**SHINE MEDICAL TECHNOLOGIES, INC.**

**SHINE MEDICAL TECHNOLOGIES, INC. APPLICATION FOR CONSTRUCTION PERMIT  
PRELIMINARY SAFETY ANALYSIS REPORT REVISIONS**

**REVISION 1 OF THE SHINE RESPONSE TO RAI 12.1-1 AND RAI 12.2-1**

**PRELIMINARY SAFETY ANALYSIS REPORT CHANGES  
(MARK-UP)**

Figure 12.1-1 – SHINE Operational Organization Chart

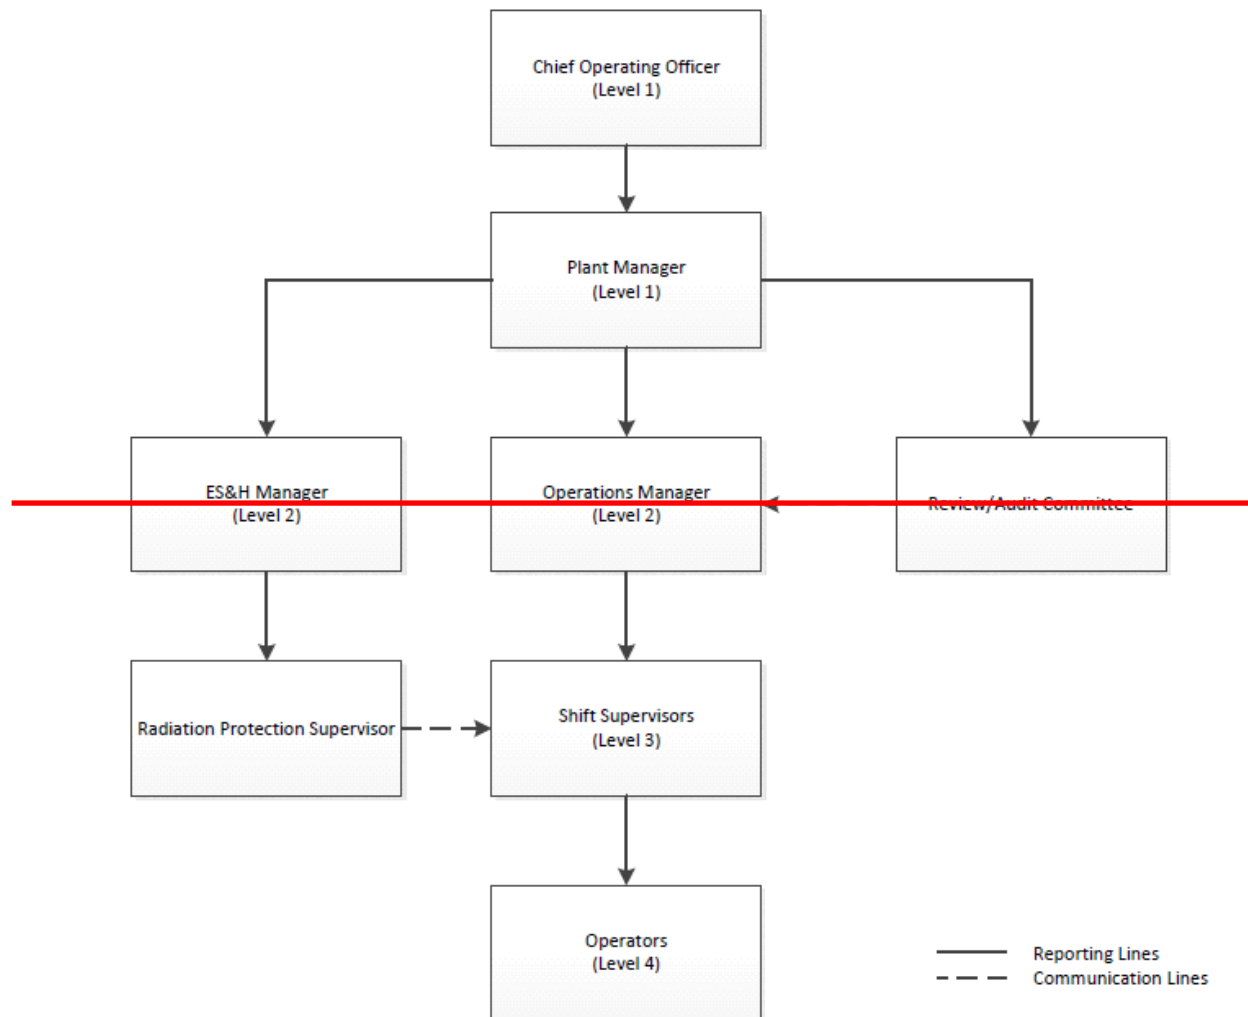
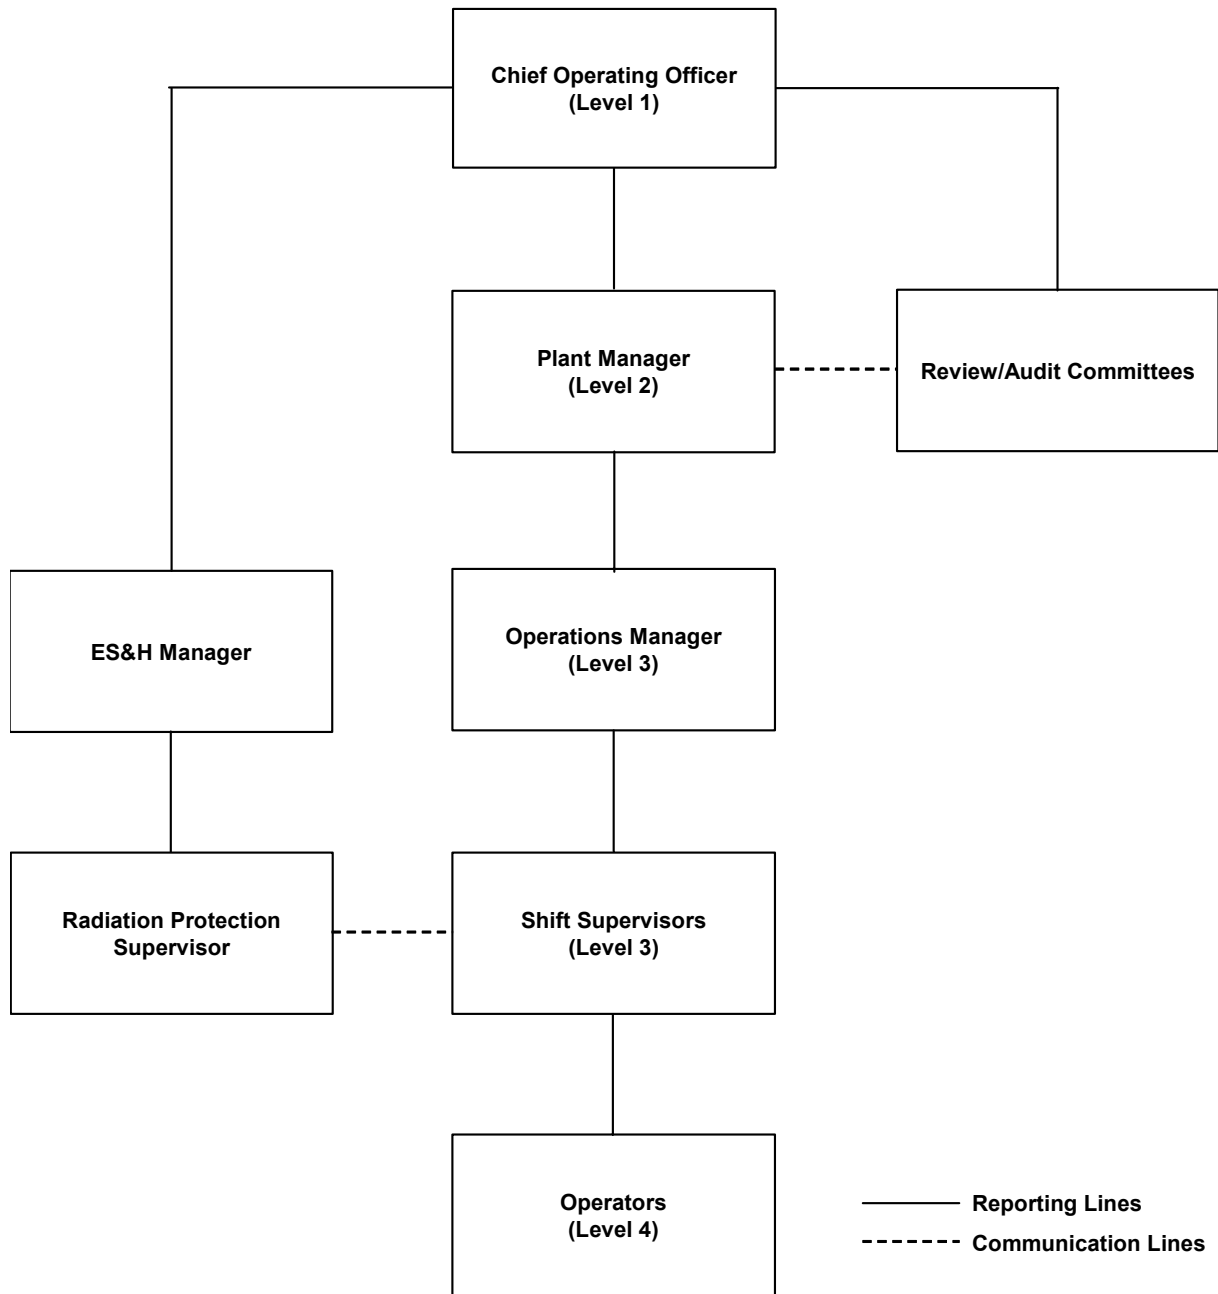
Plant Operators (Level 4) report directly to the Shift Supervisors (Level 3). The RP Supervisor reports directly to the Environment, Safety, and Health (ES&H) Manager (~~Level 2~~) and has communication lines with the Shift Supervisors. The Shift Supervisors report directly to the Operations Manager (Level ~~2~~3). The Operations Manager reports to the Plant Manager (Level 2). The ES&H Manager reports to the Chief Operating Officer (Level 1). The Review/Audit Committees reports to the ~~Plant Manager (Level 1)~~Chief Operating Officer and ~~has have~~ communication lines with the ~~Operations Plant~~ Manager. ~~The ES&H Manager and Operations Manager report to the Plant Manager.~~The Plant Manager reports to the Chief Operating Officer (~~Level 1~~).
